RFP NO. 872

ADDENDUM NO. 3

Subject: RFP No. 872: Foreign Object Debris (FOD) Detection System

**Attachment No. 1  
Proposed Questions and  
Associated County Responses**

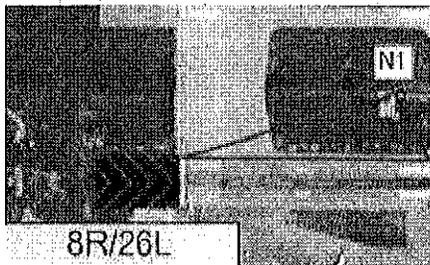
**Q 24.** Can you identify where the “headend” equipment for this FOD Detection System will be located?

**A 24.** The servers and equipment may be located in the eastern portion of the North Terminal or Building 3030. The locations of these buildings are shown in the diagram below.

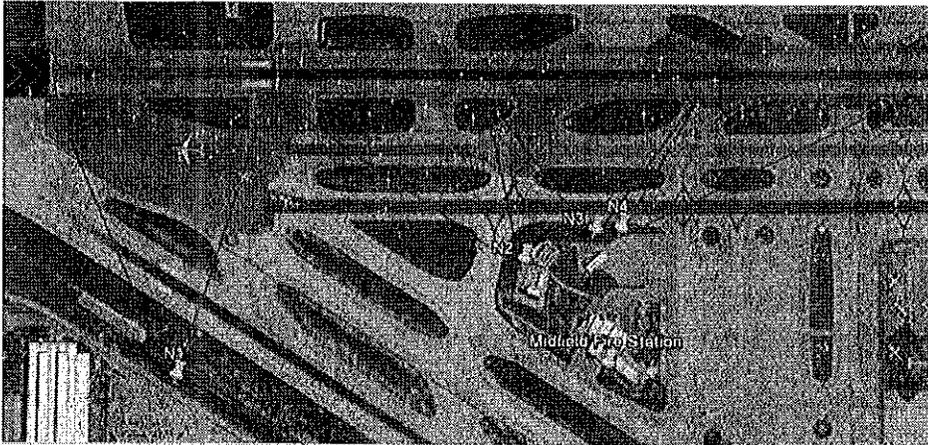
**Q 43. Is there any constrain to install an approximately 16:4ft (5m) high iFerret tower above runway center line at location mark N1 (which is to be situated behind the ILS and about 400 ft from the runway center line) for iFerret Electro-Optics Sensor Mounting (picture below)?**

**Q 44. If N1 (above picture) is to be installed here, is there any available Fiber Optics for tapping around the N1 vicinity?**

**Q 45.** Is there any constrain to install an approximately 36ft (11m) high iFerret tower above runway center line at location mark at N1 for iFerret Electro-Optics Sensor Mounting (picture below)?

**Q 46.** Is there any constrain to install a 33ft (10m) high iFerret tower above runway center line at location mark at N2, N3, N4 for iFerret Sensor Mounting (see figure above)?

**A 43.** *The structure as shown penetrates the FAR Part 77 surfaces and would require FAA review.*

**A 45.** The structure as shown penetrates the FAR Part 77 surfaces and would require FAA review and approval.

**A 46.** A tower installed within these locations may conflict with a Taxiway Object Free Area and would require FAA review and approval.

DESIGN GUIDELINES MANUAL—VOLUME 5 MIAMI DADE AVIATION DEPARTMENT MIAMI INTERNATIONAL AIRPORT	REVISED  10/04 NOV 1993	1T  SHEET 2 OF 4
	TRENCH SECTIONS FOR TRAFFIC CRITICAL AREAS

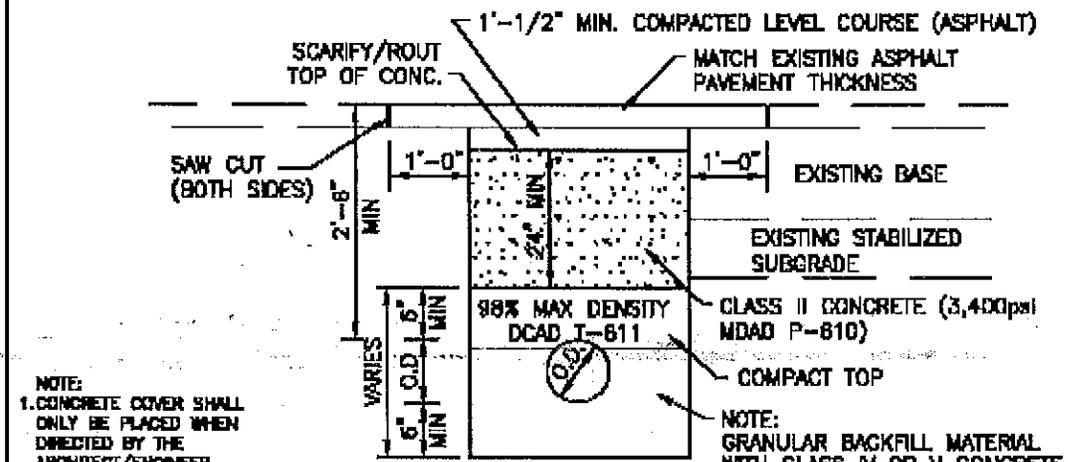
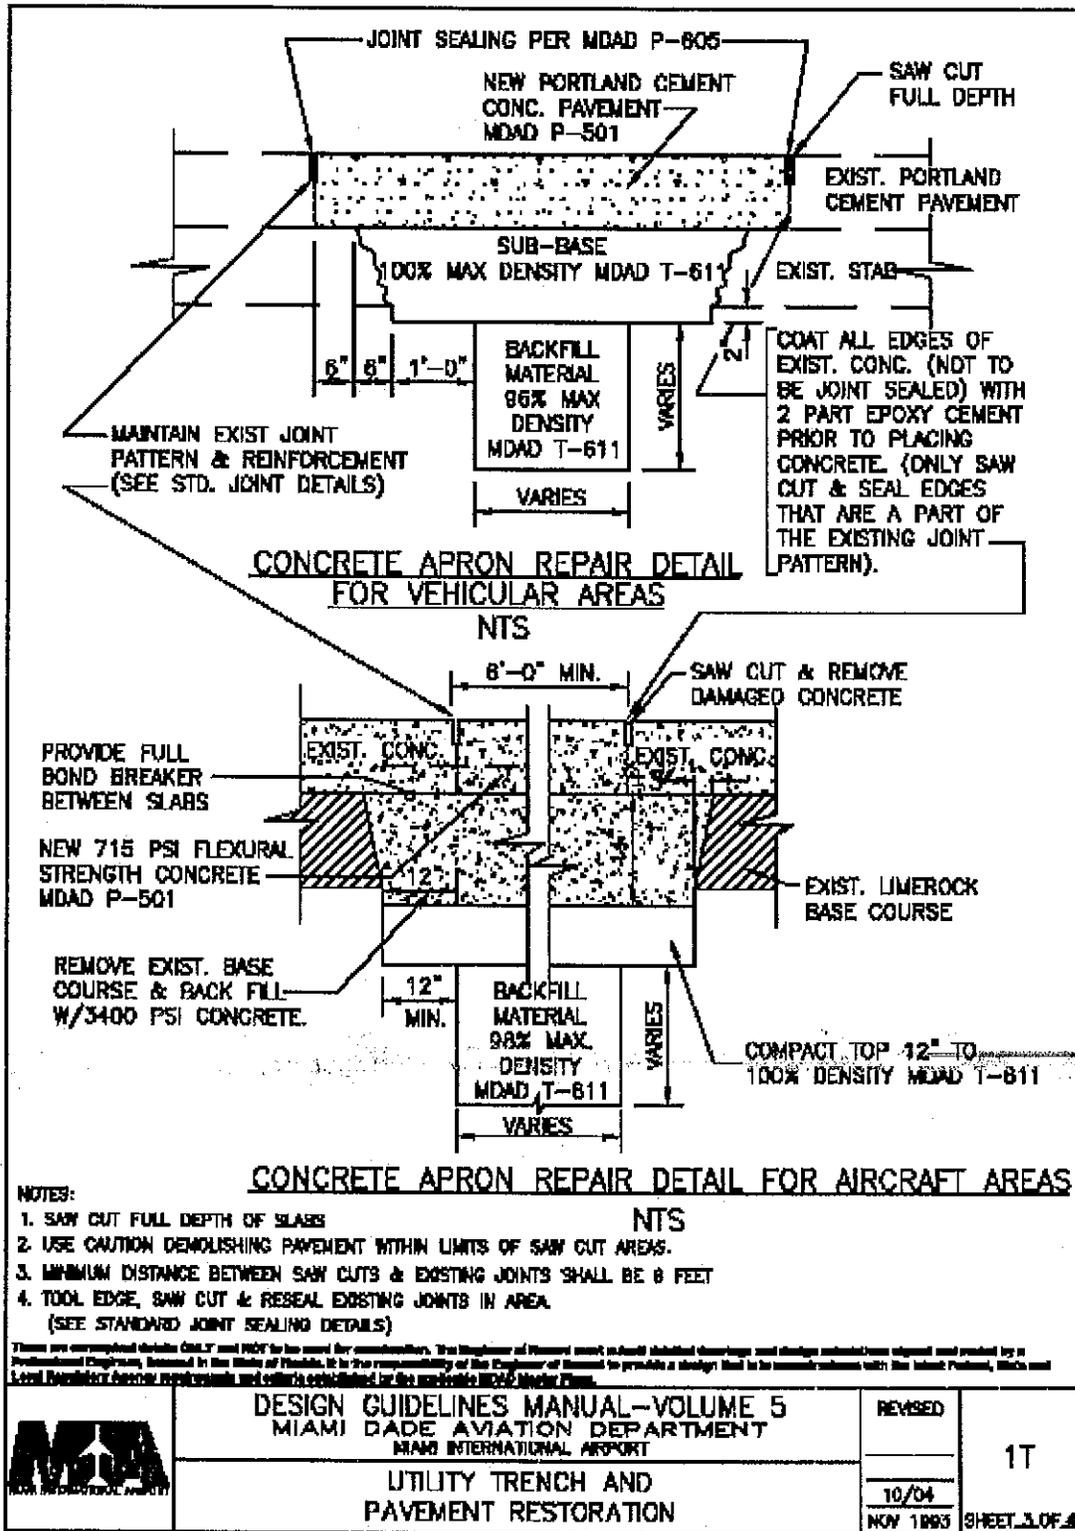
**Q 61.** Please provide a detail diagram for repair of a sawcut in the shoulder area?

**A 61.** *The MDAD Standard Details for pavement restoration associated with utility trenches are below. The selection of the appropriate repair is predicated on the location, type of traffic (aircraft or vehicular), trench width, type of utility and pavement (flexible or rigid). In flexible (asphalt) pavement, the saw cut is normally full depth; the subsequent restoration will require tack coating along the edge of the sawcut and the new pavement matching the existing asphalt thickness. Depending on the trench width, concrete may also be cast to the surface, and subsequently milled and overlay with asphalt. It should be noted that MDAD will not allow a sawcut in pavement for the sole purpose of installing direct buried cables.*
